# Access Compliance Report

## Public Rights-of-Way (Curb Ramps)

| Intersection ID: 11304                  | Main Street: NATIONS_FORD_RD | Cross Street: MARSHALL_AIR_DR           | Location: SE           |
| ADA ID: 0EB6C9AD02DF                    | Ramp Type: Perp              | Initial Pass/Fail: Fail                 | Overall Compliance: No |

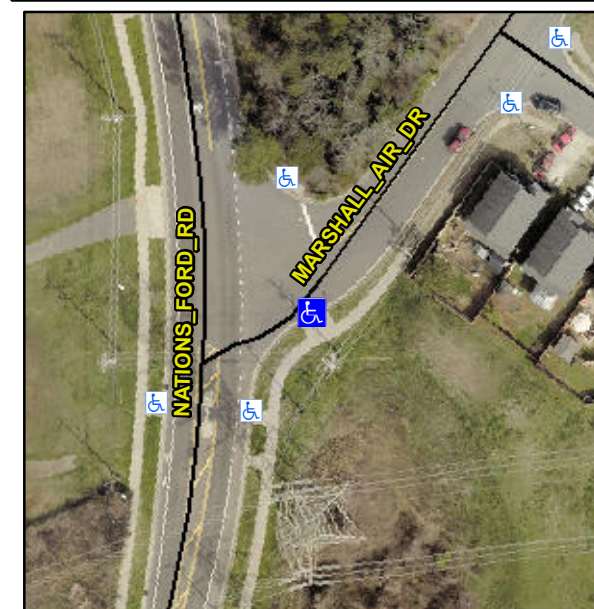
**Not Found, R304.5.1, R304.2.2, R304.5.3**

| Compliance | Description           | Data | Compliance | Description                 | Data |
|------------|-----------------------|------|------------|-----------------------------|------|
| N/A        | Ramp Length (in)      | 96.0 | No         | Ramp Slope (%)              | 8.8  |
| No         | Ramp Width (in)       | 46.5 | No         | Ramp XSlope (%)             | 4.2  |

**Remove & Replace Entire Ramp.**
